DART AEROSPACE LTD		Work Order:	129298
Description: Crosstube Assembly		Part Number:	D407-667-145
Inspection Dwg: D407-667-145 Rev: C		Page 1 of 2

DRAWING NO. D407-667-145
TITLE CROSSTUBE ASS'Y (407 HIGH FWD)

DRAWING NO. D407-667-145	TITLE CROSSTUBE ASS'Y (407 HIGH FWD)	REV. C	DART AEROSPACE LTD ENGINEERING ORDER		D.E.O. NO. D407-667-145-C-1	SHEET NO. SHEET 1 OF 1	SCALE NTS
DRAWN 92	CHECKED ASS	MFG. APPR. IB	APPROVED WD		DE APPR. H		
DATE 11.07.15	DATE 11.07.22	DATE 11.07.22	DATE 11/07/22		DATE 11.07.21

DRAWING NO. D407-667-145	TITLE CROSSTUBE ASS'Y (407 HIGH FWD)	REV. C	DART AEROSPACE LTD ENGINEERING ORDER		D.E.O. NO. D407-667-145-C-2	SHEET NO. SHEET 1 OF 1	SCALE NTS
DRAWN AJG	CHECKED [Signature]	MFG. APPR. [Signature]	APPROVED [Signature]	DE APPR. [Signature]			
DATE 12.08.02	DATE 12.08.02	DATE 12.08.02	DATE 12.08.02	DATE 12.08.02

DETAIL P
BONDING STRAP INSTALLATION 2 PL

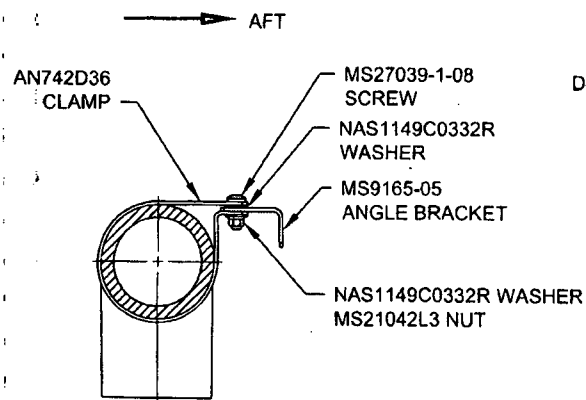
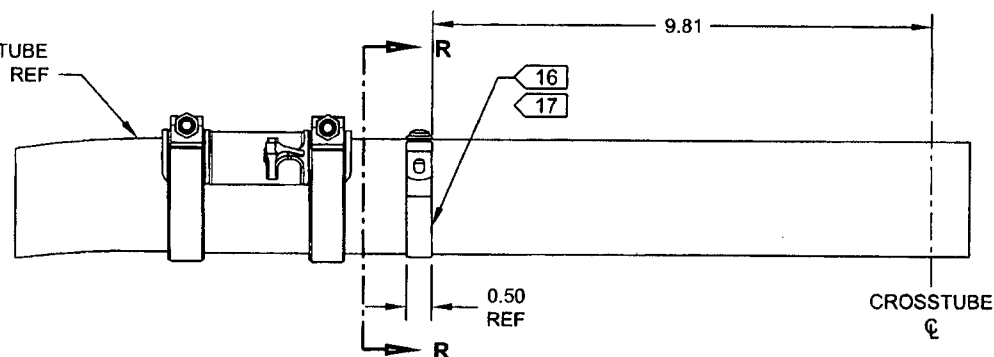
ADD ELECTRICAL GROUNDING STRAP

ITEM	QTY -145	PART NUMBER	DESCRIPTION
1	X	D407-667-145	CROSSTUBE ASSEMBLY (407 HIGH FWD)
10	2	AN742D36	CLAMP
11	2	MS9165-05	ANGLE BRACKET
12	2	MS21042L3	NUT (OR MS21042-3)
13	2	MS27039-1-08	SCREW
14	4	NAS1149C0332R	WASHER (OR AN960C10L)

- 16) MASK AREA UNDER CLAMP PRIOR TO PAINTING
- 17) SEAL EDGES WHERE AN742D36 CLAMP MEETS WITH THE CROSSTUBE USING SIKAFLEX-241/-291 OR MIL-S-8802 CLASS B2 OR PROSEAL 890 SEALANT
- 18) PERFORM RESISTANCE CHECK TO ENSURE MAX RESISTANCE IS 10 MILLIOHMS
